SCDOT

Value Engineering Study

**I-73 Southern Section
Right-of-Way Plans**

Southbound Ramp

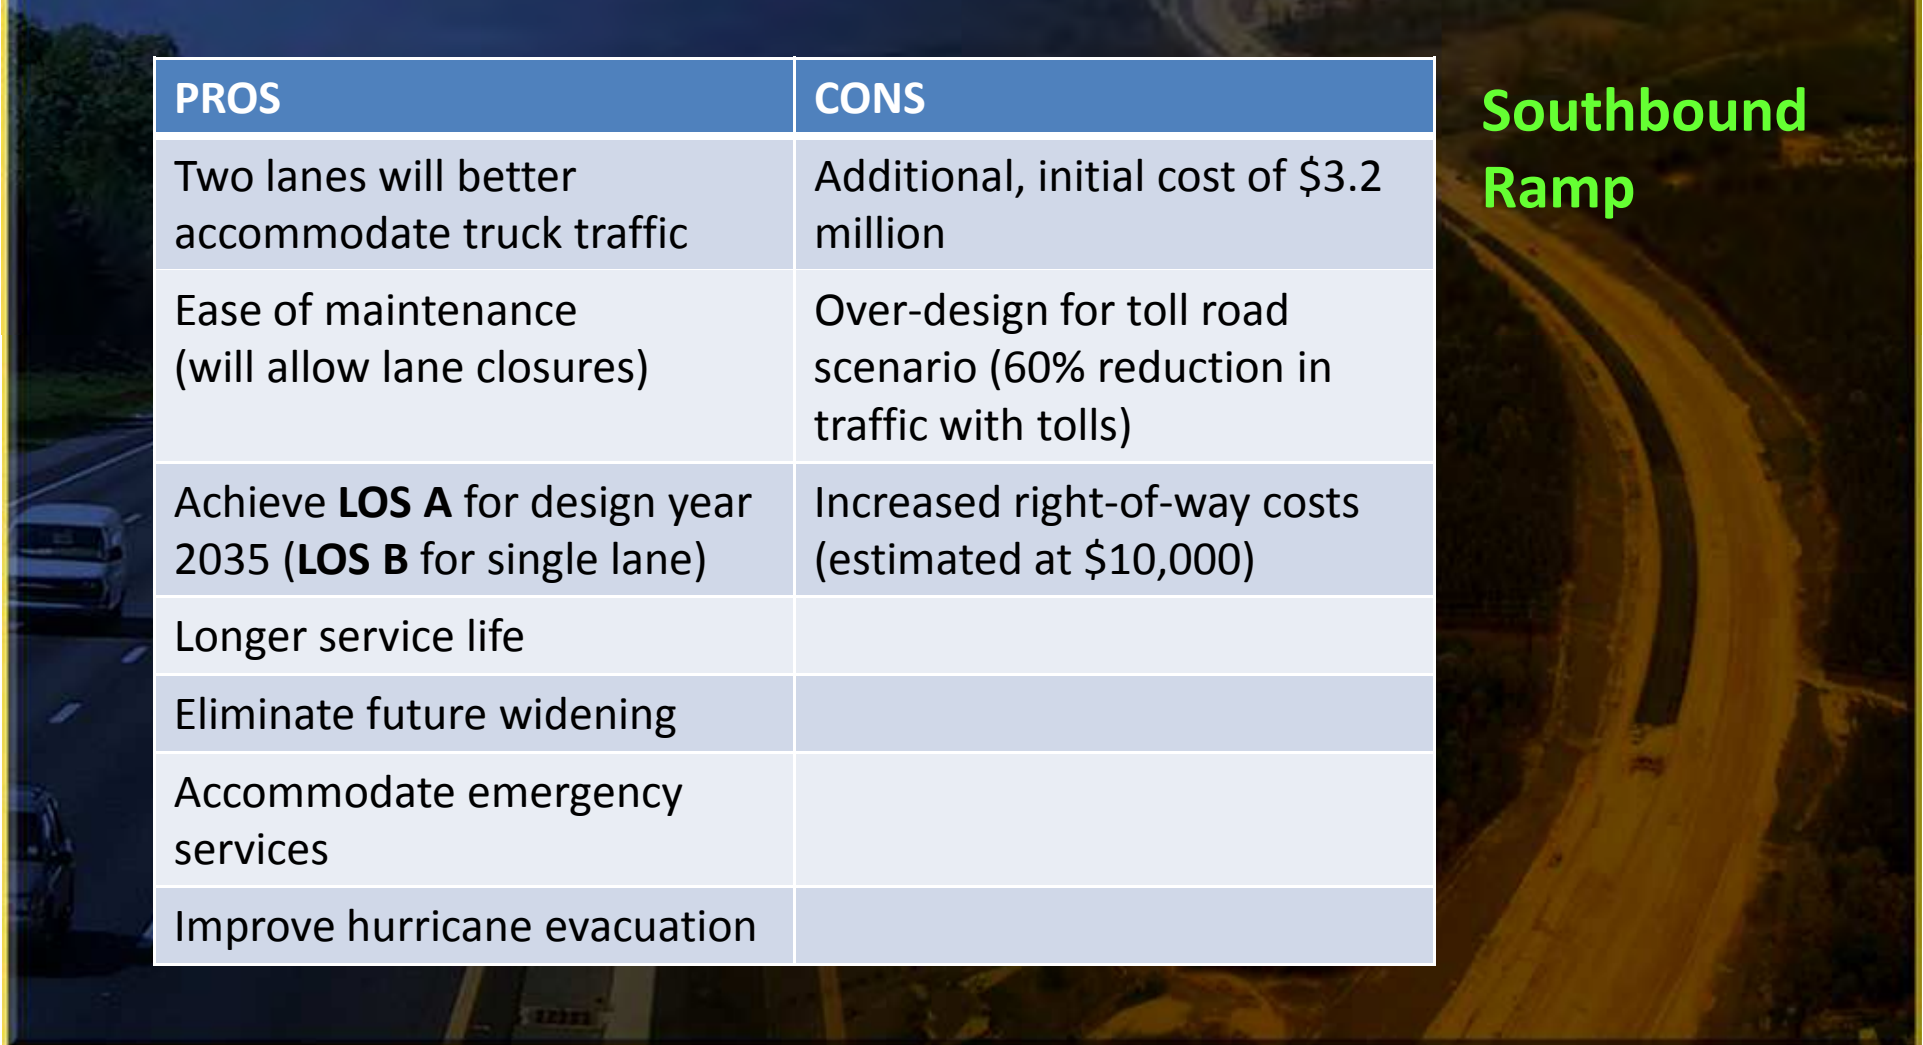
Widen the two main interchange ramps from one, 16' lane to two, 12' lanes.

I-73/SC 22 Interchange: Original Directional Interchange

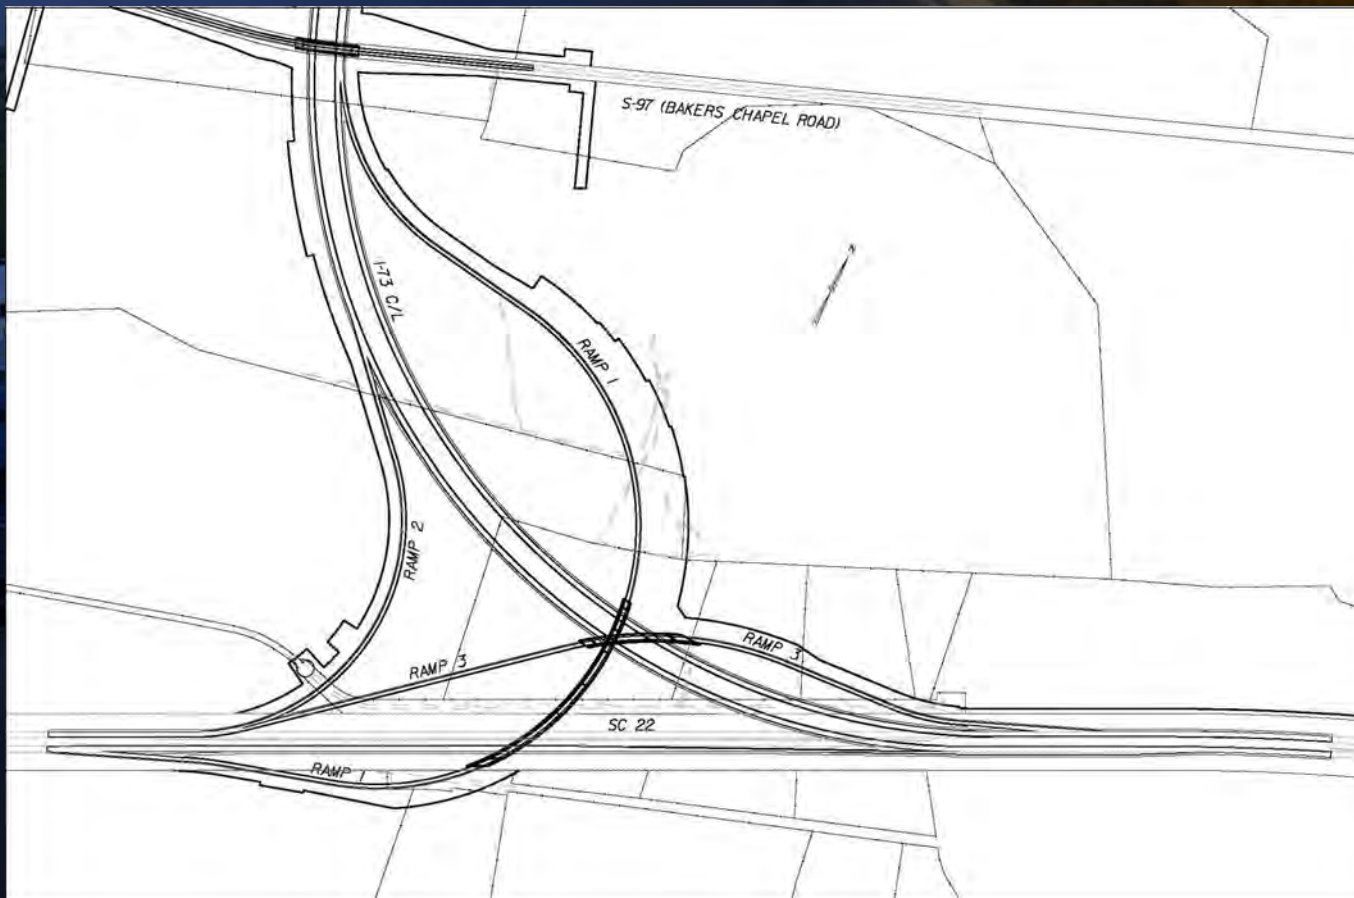
Revise current three-level, multiple structure interchange to a T-type, trumpet design.

I-73 adjoins SC 22 just east of the SC 22/SC319 interchange and will continue eastward towards Conway. The VE Study Team discussed the possibility of revising the I-73/SC 22 Interchange to a one-lane or two-lane trumpet design instead of a system-to-system directional interchange. The VE Study Team requested that the Design Team evaluate the possibility of using a compound curvature for the loop ramp.

PROS	CONS
Reduce ramp fill heights and bridge requirements for a cost savings estimated at \$31.1 million	Safety issues with loop design
Lessen length of Bakers Chapel Road crossing bridge (end acceleration lane prior to crossing under the Bakers Chapel Road bridge)	Two of the four ramps will have reduced (60-40-60 mph) design speeds – directional ramps are all 55 mph
No conflict with hurricane evacuation	May require reopening the EIS to assess impacts
Handle estimated volumes at design year (with projected SELL project volumes)

Interchange at S308:

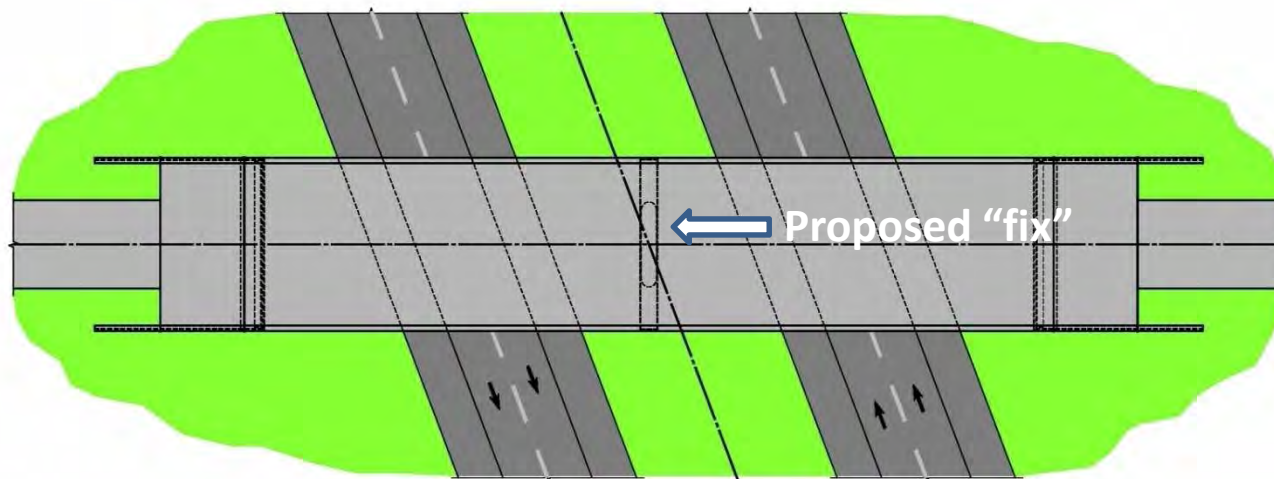
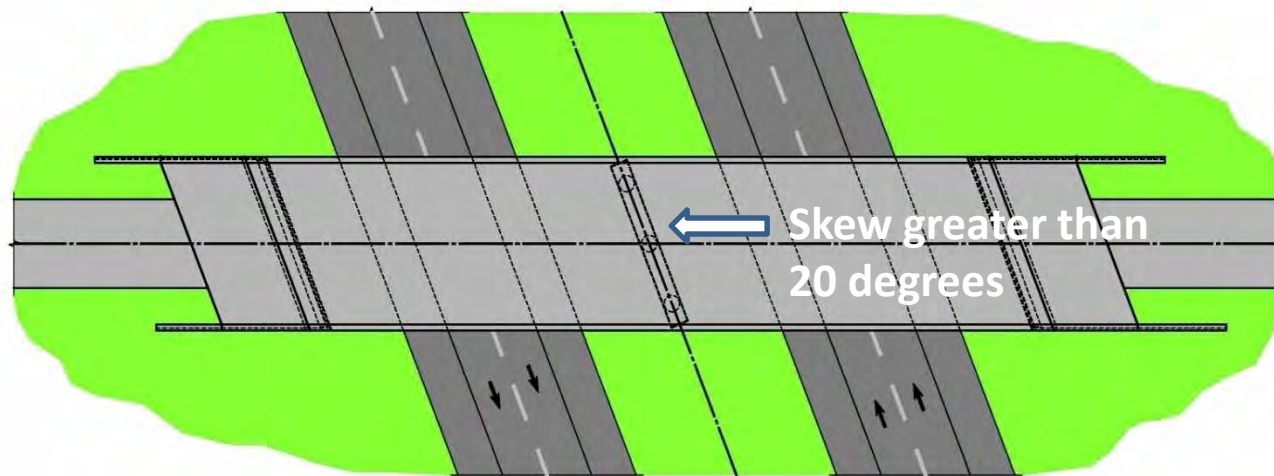
The VE Study Team asked the Design Team to provide justification for the S308 interchange and for the location chosen for that interchange.

- ▶ Without the S308 interchange, there was no access between US 701 and US 76 interchange, a distance of over 25 miles.
- ▶ Other potential locations are at S23 (South Nichols Highway) or S99 (Lake Swamp Road). The communities at S23 and S99 did not want the interchange at those locations, fearing an interchange would alter the character of the community.
- ▶ There would be additional relocation impacts at either S23 or S99.
- ▶ Ketchup Town, located on S99, is considered to be a local landmark and would be impacted significantly by the interchange.
- ▶ Horry County requested the S308 location for the interchange to provide more direct access to the Cool Springs Industrial Park.
